RAMP REPORT REGION 2 ADA 2026

Hills to Sea Trailhead,  
Unity

CR12756

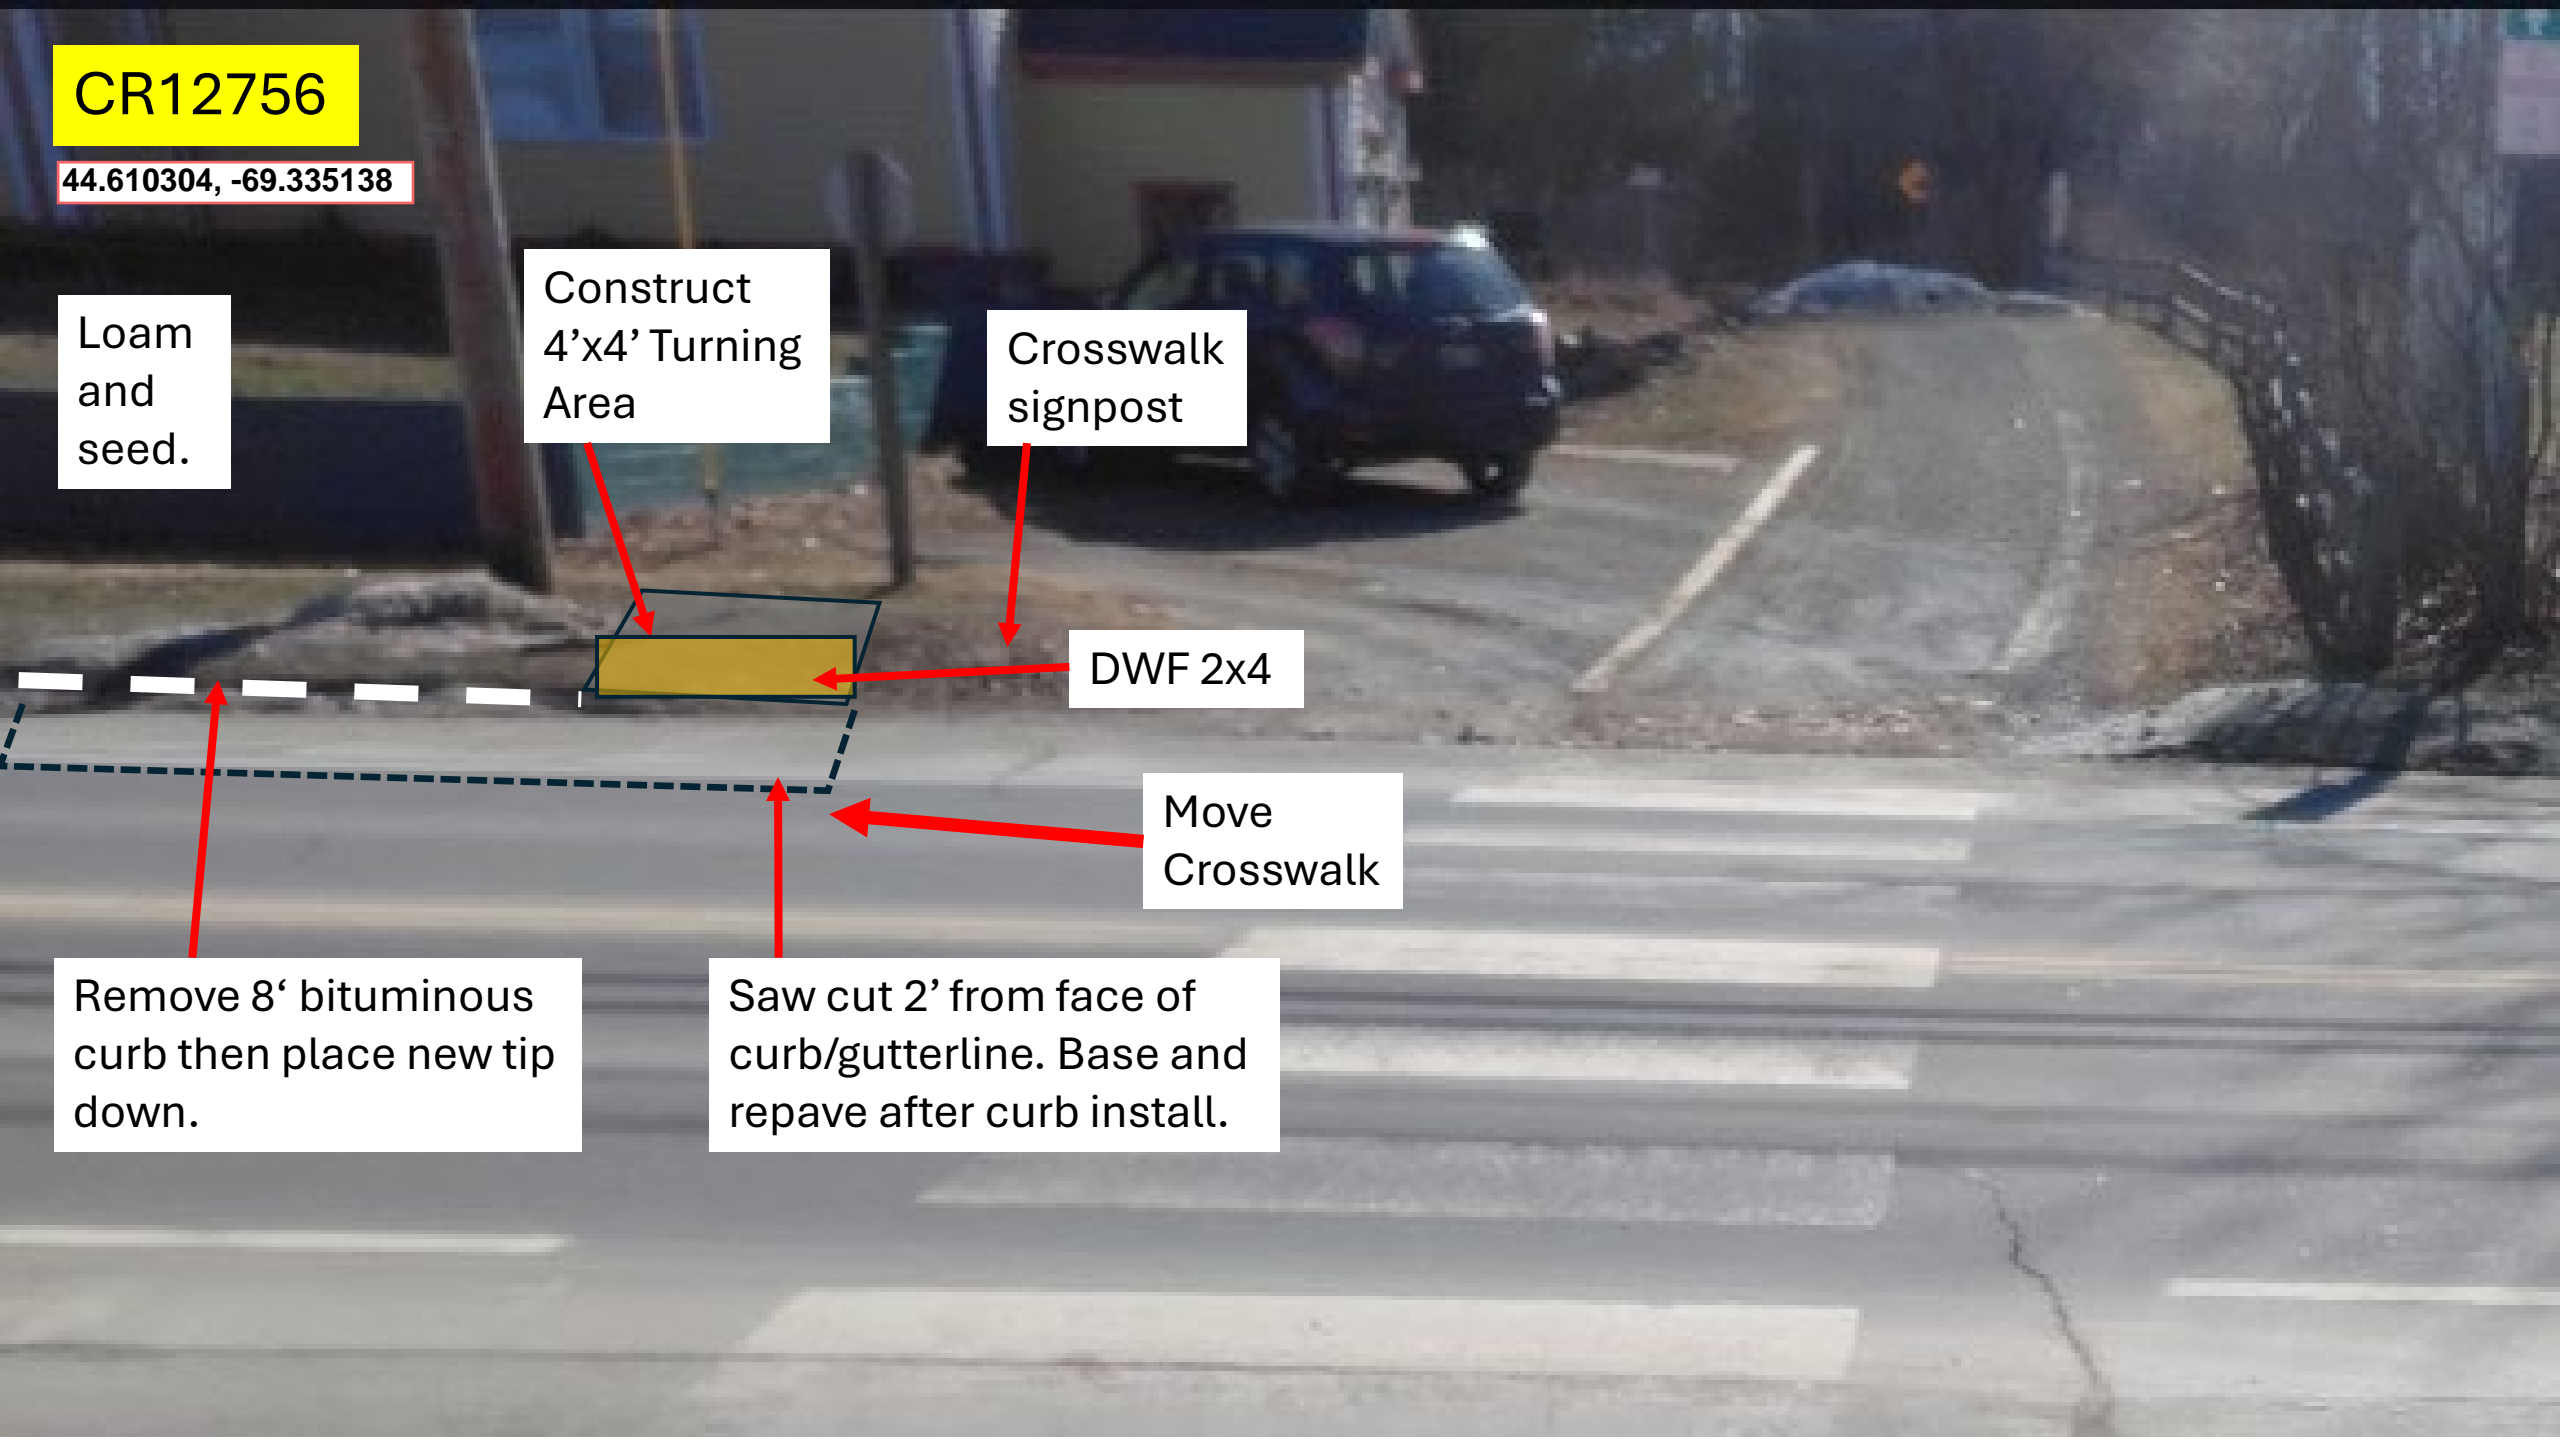
Loam and seed.

Construct 4'x4' Turning Area

Crosswalk signpost

DWF 2x4

Move Crosswalk

Remove 8' bituminous curb then place new tip down.

Saw cut 2' from face of curb/gutterline. Base and repave after curb install.

CR12757

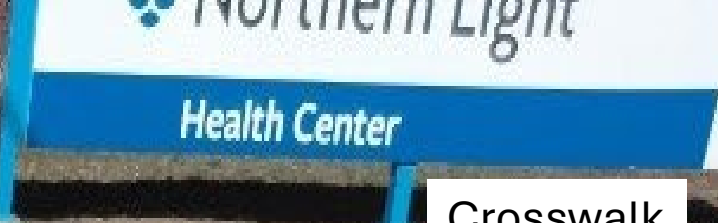
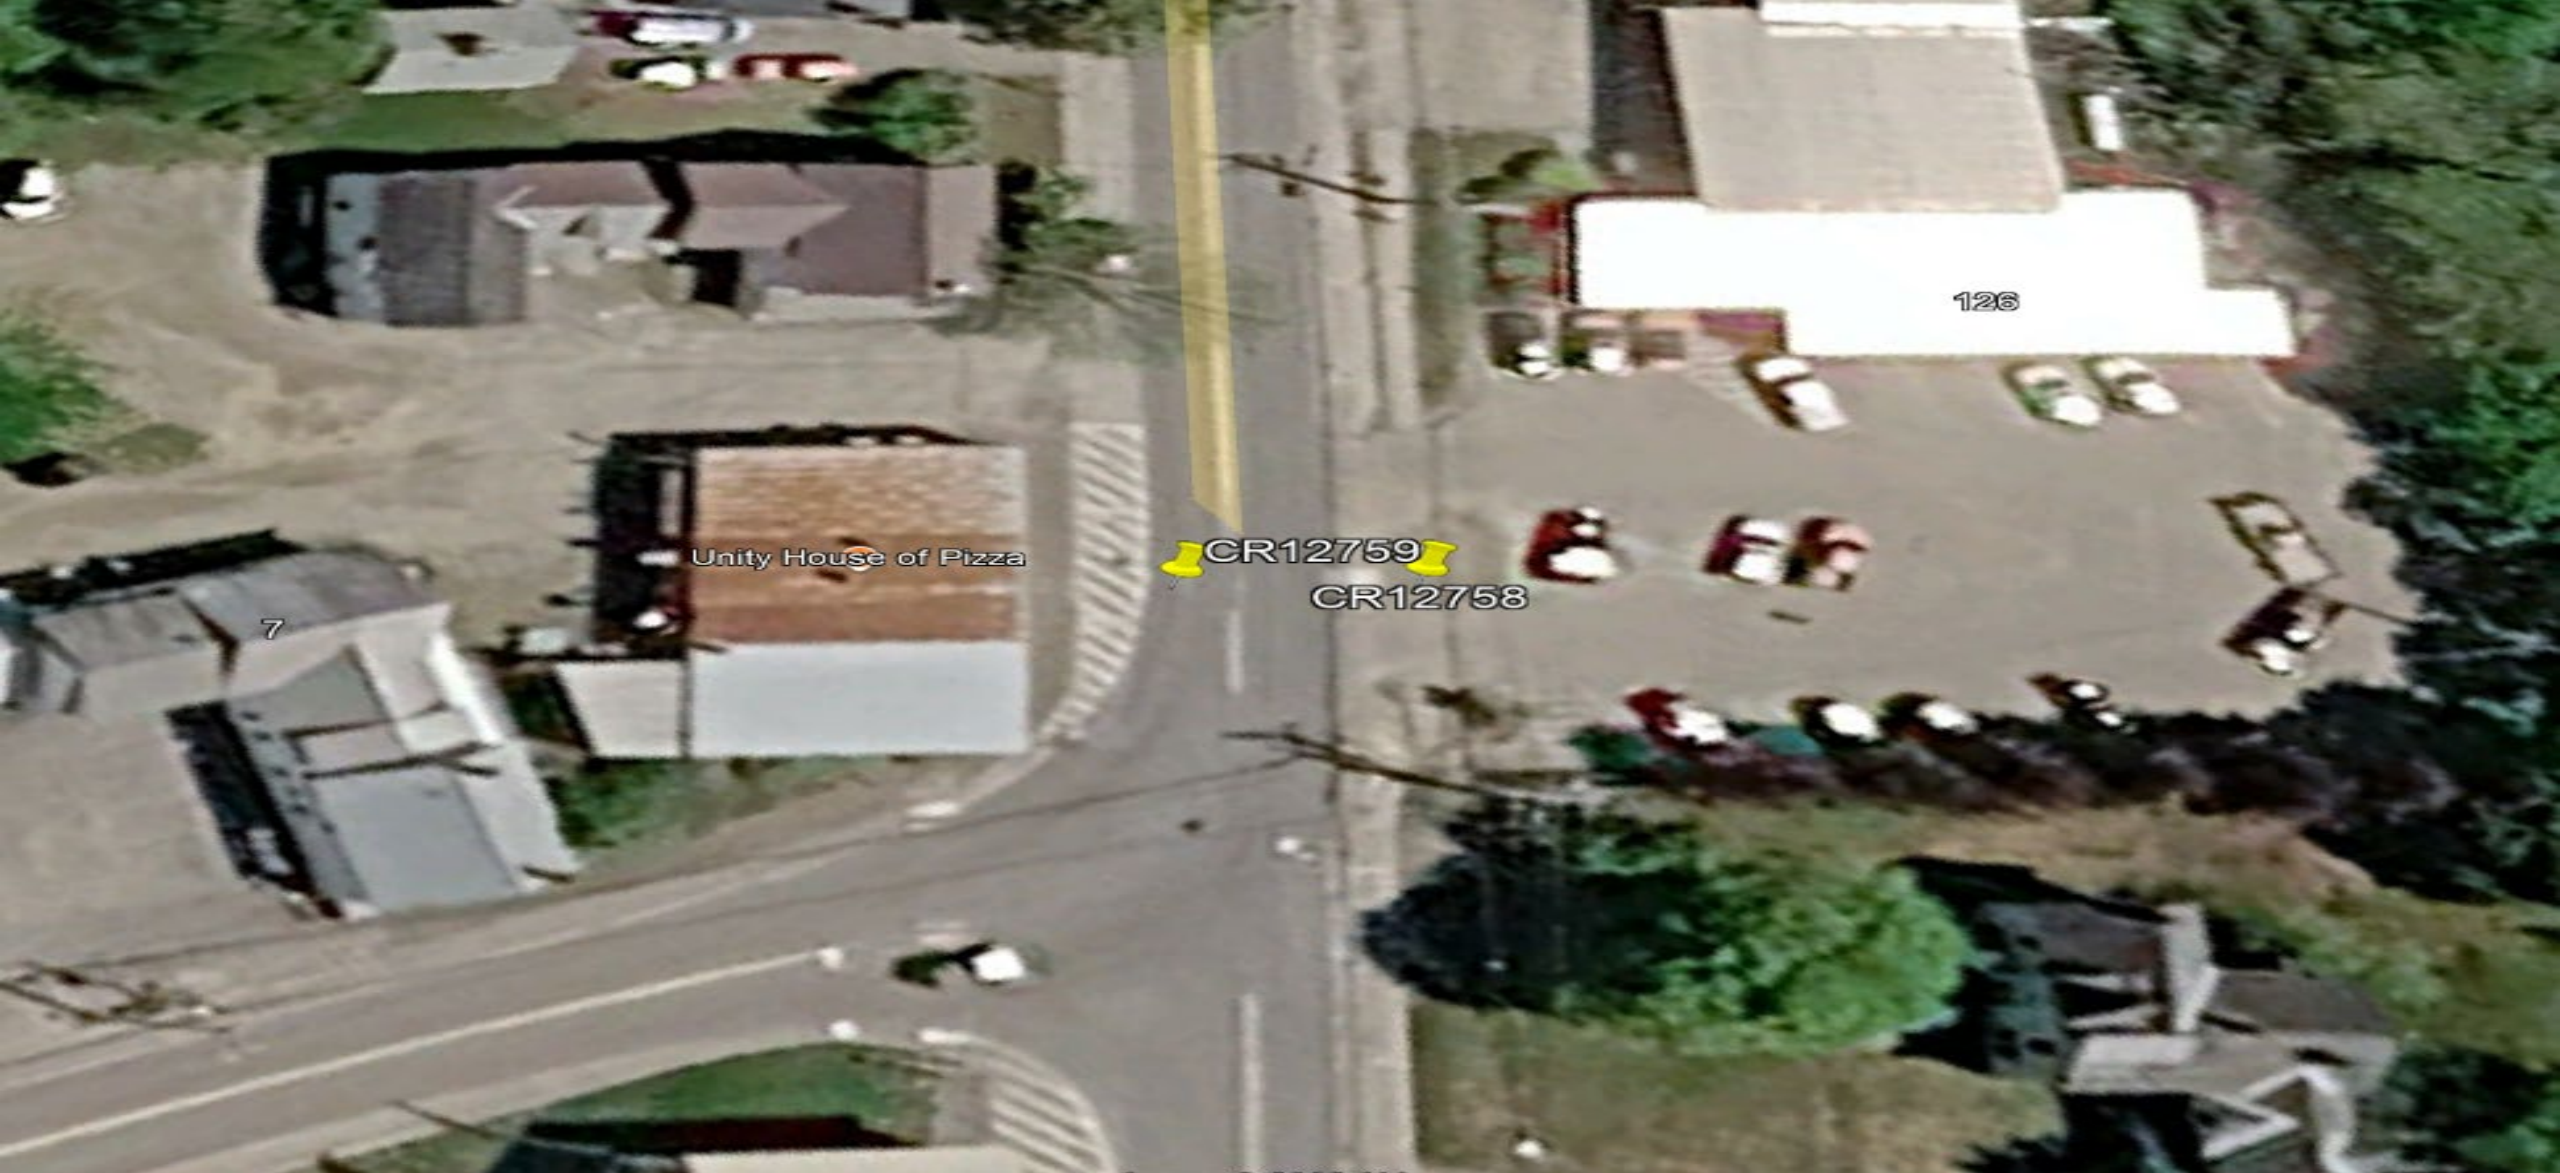
Loam  
and  
seed.

4'x4'  
Turning  
area

Remove and regrade  
sidewalk.

Crosswalk  
signpost

Remove 15' bituminous  
curb then place new tip  
down.

Saw cut 2' from face of  
curb/gutterline. Base and  
repave after curb install.

DWF 2x5

Remove 15' bituminous  
curb then place new tip  
down.

Move  
Crosswalk

CR12759

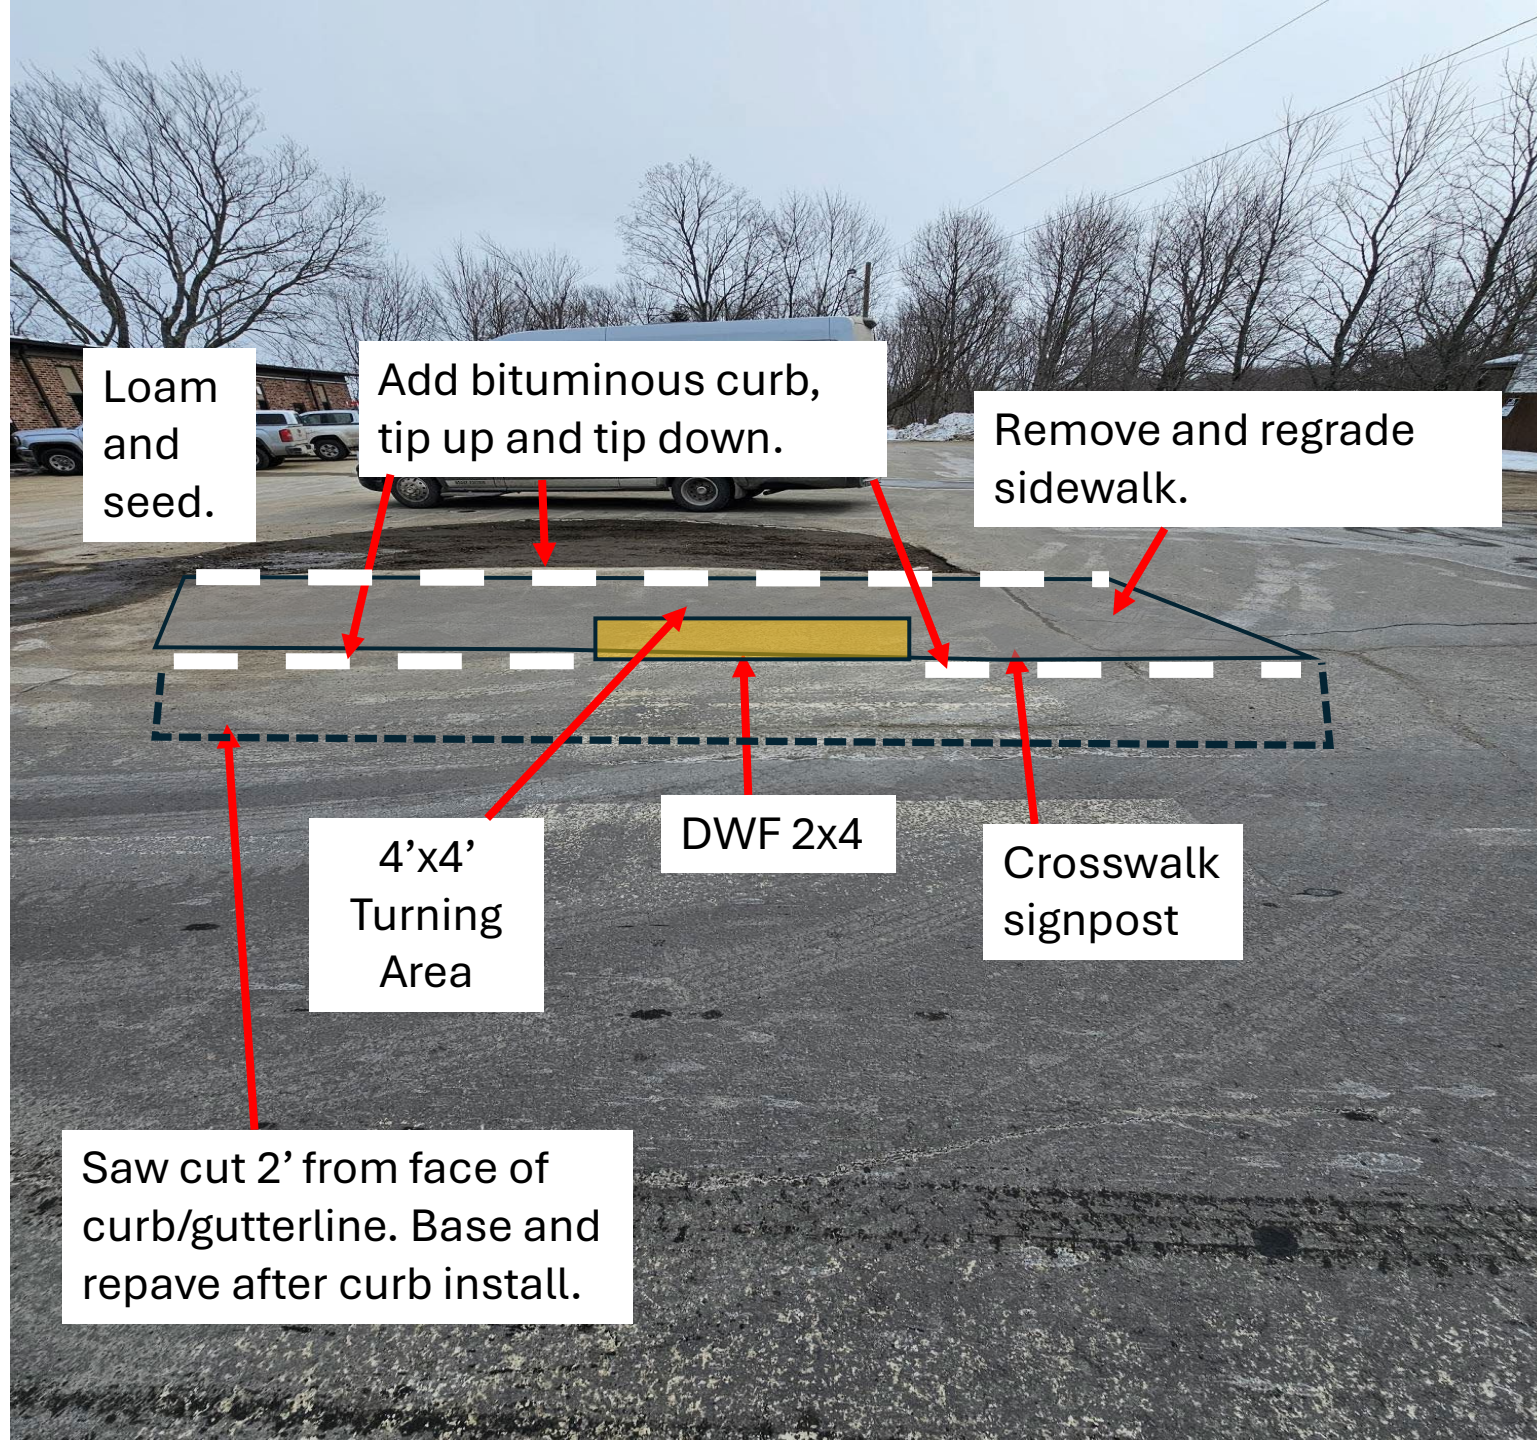
Remove and regrade sidewalk.

DWF 2x5

4'x4'  
Turning  
Area

Crosswalk  
signpost

Saw cut 2' from face of  
curb/gutterline. Base and  
repave after curb install.

Remove 8' bituminous  
curb then place new tip  
down.

CR12758

Loam and seed.

Add bituminous curb, tip up and tip down.

Remove and regrade sidewalk.

4'x4' Turning Area

DWF 2x4

Crosswalk signpost

Saw cut 2' from face of curb/gutterline. Base and repave after curb install.
